Design Review Commission Report

Subject: **718 North Canon Drive (PL# 120 2375)**
A request for an R-1 Design Review Permit to allow for a new two-story single-family residence located in the Central Area of the City north of Santa Monica Boulevard.

Answer to the Commission Comments on July 9, 2012:

WEST ELEVATION (Canon Dr.)
SCALE: 1/4" = 1'-0"
(DESIGN-1)

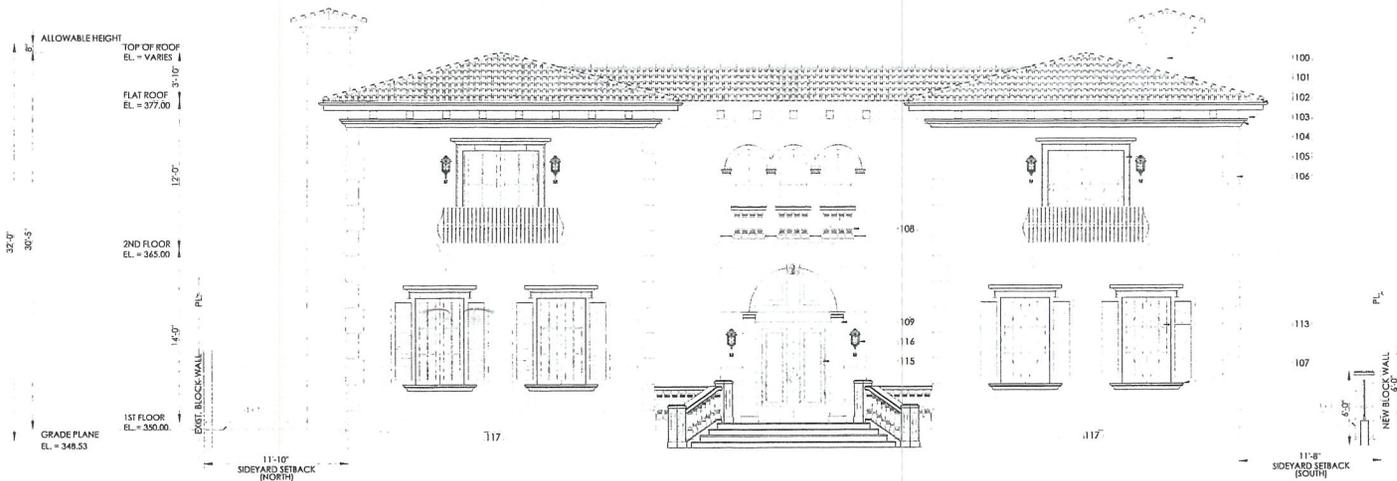
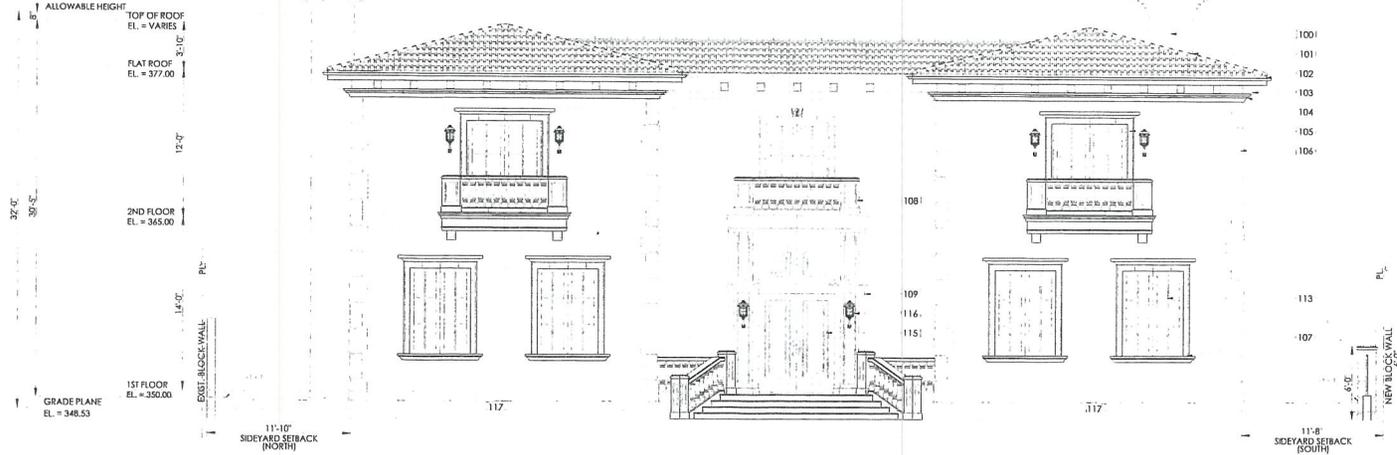
- 1) The first floor massing does not work. There are better ways to incorporate balconies without having two boxes on the first floor.
- 2) The bulk of space needs to be readjusted to reduce the boxy look of the facade.
We eliminated the 1st floor box modulation with the balcony on top and instead maintained the front facade flat (as per commissioners' suggestion) and incorporated a Juliet balcony with less balustrade (Design-1) or Juliet balcony with wrought iron railings (Design-2).
(See pictures of Architectural Concept A-14.3)

- 3) The horizontal molding is too heavy for the facade.
We completely eliminated the running horizontal molding.
- 4) The entrance is nice but the molding around the door is too heavy. Focus more on the door and allow the openings above the door to be their own element; the entry should be restudied and unified.
Main entry was redesigned so as to unify the three arch opening on the 2nd floor (Design-1); or unify with the door opening on the 2nd floor (Design-2).
(See pictures of Architectural Concept A-14.3)

- 5) The pediments above the first floor windows are awkward and do not fit with the windows.
The combination of pediments above the first floor windows and shutters is not rare for Italianate style of Architecture (See pictures of Architectural Concept A-14.3). But having said that we reconsider the suggestion and instead of totally removing it, we simplified the design of the said pediments so as to compliment the use of the shutters rather than making it look awkward.

- 6) There are too many pilasters with balustrades on the balconies.
(Design-1 & 2) Juliet balcony with less use of balustrade.
(Design-1 & 2 alternatives) Juliet balcony with metal and wrought iron railing.

- 7) The windows should have more depth to them.
Main entry door is setback 30 inches.
All windows on the first floor are setback 18 inches.
2nd floor door to Juliet balcony is also setback 18 inches.

- 9) The shutters are nice but are too small and out of proportion with the windows.
Since we gained some wall width on both sides by eliminating the protruding part of the first floor, we redesigned the shutters to be proportionate with the width of the windows.
